ADA ASSESMENT REPORT
POTENTIAL SITE FOR DERBY TAGS/APPRaiser'S OFFICE
212 W. GREENWAY, DERBY, KS
CONDUCTED: MARCH 27, 2007
REPORT DATE: APRIL 3, 2008 (with Modifications April 17, 2008)

The following ADA site assessment was performed on March 27, 2008 upon request of April Powell, Project Manager for Sedgwick County Project Services. The following items reflect structural inconsistencies found at the property. It is understood that the existing interior of the property will be completely demolished as part of the interior renovation. As such, the ADA deficiencies currently on the interior of the building would be expected to be corrected as part of the completed interior renovation.

ACCESSIBLE PARKING and ACCESSIBLE ROUTE: West of Main Entrance

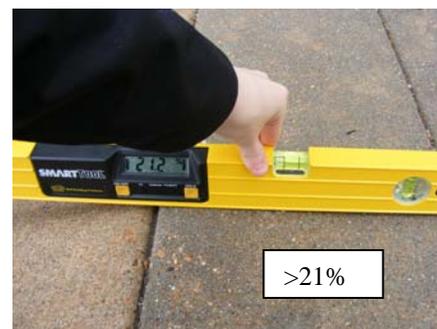
EXISTING CONDITION: Accessible parking spaces west of main entrance exceed allowable slope as shown above. Existing slopes measured over 4%.

The surfaces, of designated accessible parking spaces and access aisles to the west of the main entrance, have slopes exceeding 2%. ADAAG requires accessible parking spaces and access aisles to have surface slopes that do not exceed 2%.

EXISTING CONDITION: No upright signs are provided to designate accessible parking.

ADAAG requires accessible parking spaces to have upright signage that includes the symbol of accessibility and van accessible signage where required. Such signs are required to be located so they can be seen with a vehicle parked in the space. This requirement can generally be adhered to with the sign mounted at 5-feet high measured to the bottom of the lowest sign.

EXISTING CONDITION: Van accessible parking spaces exist, but van accessible signage does not.

If parking spaces are provided for self-parking by employees or visitors, or both, then accessible spaces complying with 4.6 shall be provided in each such parking area in conformance with the table shown in (5)(a). In addition, one in every eight accessible spaces, but not less than one, shall be served by an access aisle 96 in (2440 mm) wide minimum and shall be designated "van accessible."

Repave to correct slope or provide other accessible parking at another location, which is still on the shortest path of travel to accessible entrance (** see recommendation below). Ensure that a fully accessible path of travel exists leading from accessible parking to the facility entrance.

Provide upright signage in front of each existing accessible vehicle parking space, which complies with ADAAG specifications.

Provide van accessible signage at, at least, one van accessible parking space.

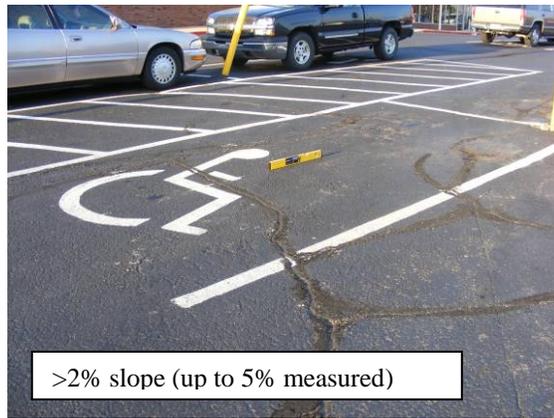
EXISTING CONDITION: The curb ramp west of the main entrance, connecting the street (parking lot) level with the sidewalk level, does not provide an appropriate detectable warning surface and has very steep side flares. Since this curb ramp leads to a cross vehicular traffic way, the necessity of a detectable warning surface is magnified. The existing curb cut has a detectable warning surface. However, this detectable warning does not comply with current ADAAG specifications regarding truncated domes. ADAAG requires side flares on curb ramps to be a maximum slope of 1:10. The existing side flares have more than a 21% slope.

Modify the existing curb cut to comply with ADAAG specifications pertaining to a detectable warning surface and slope of side flares or provide a new curb cut (** see recommendation below). Note that the curb ramp should be located to coordinate with the travel path from the accessible parking, which should not exceed 2% cross slope.

ACCESSIBLE PARKING and ACCESSIBLE ROUTE: *East of Main Entrance*
(identified in Kent Johnson's November 2006 report)

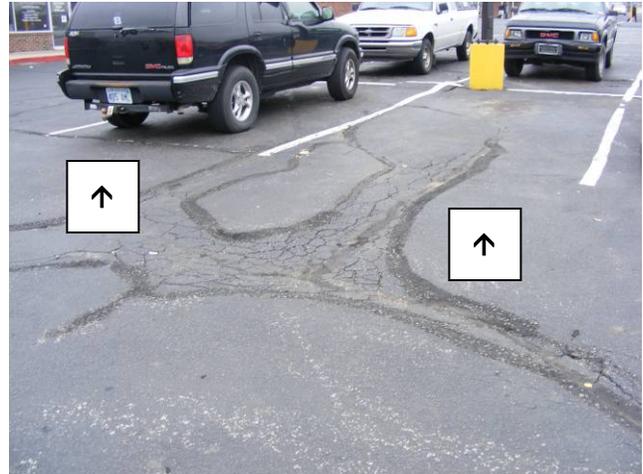
EXISTING CONDITION: The surfaces of designated accessible parking spaces and access aisles east of main entrance are not accessible due to cracked asphalt and slopes beyond 2% (as identified in Kent Johnson's November 2006 report).

EXISTING CONDITION: The upright signs, which designate accessible parking, are located too low (as identified in Kent Johnson's November 2006 report).

EXISTING CONDITION: Van accessible parking spaces exist, but van accessible signage does not (as identified in Kent Johnson's November 2006 report).

EXISTING CONDITION: The curb ramp east of the main entrance, connecting the street (parking lot) level with the sidewalk level, does not provide an appropriate detectable warning surface and has very steep side flares (as identified in Kent Johnson’s November 2006 report).

Repave the existing accessible parking spaces **or** create other accessible parking at another location, which is still on the shortest path of travel to accessible entrances (** see recommendation below). Ensure that a fully accessible path of travel exists leading from accessible parking to the facility entrance.

Raise upright signage in front of each existing accessible vehicle parking space to comply with ADAAG specifications. This requirement can generally be adhered to with the sign mounted at 5-feet high measured to the bottom of the lowest sign.

Provide van accessible signage at, at least, one van accessible parking space.

Modify the existing curb cut to comply with ADAAG specifications pertaining to a detectable warning surface and slope of side flares or provide a new curb cut (** see recommendation below).
